deHAVILLAND

DRAWN:	M. MARCUCCI	CLASSIFICATION	STANDARD
DATE:	93/06/25		
CHECKED:	<i>[Signature]</i>	EXTRUDED SHAPE	CV713
STRESS:	<i>[Signature]</i>		
APPROVED:	<i>[Signature]</i>

LEARN HAS - TOP & BTM SKINS STRS, O/WING

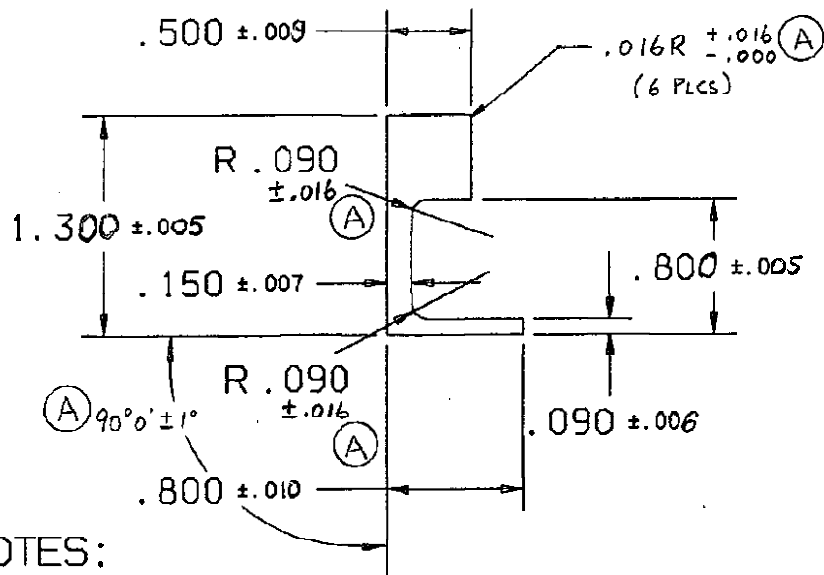
NOTE 1 CHANGED
.016 R $\pm .016$ / - .000 ADDED
WAS R .090. NOW R .090 $\pm .016$
90° 0' $\pm 1^\circ$ ADDED

- (A) 1. ~~EXTERNAL CORNERS .016 RAD~~ TOLERANCES TO
~~UNLESS SPECIFIED. FED. STD. 245 UNLESS OTHERWISE SPECIFIED.~~
2. MAT'L AL. ALLOY 7150
AMS 4345 TEMPER T77511.
3. MIN. LENGTH 21 FT.
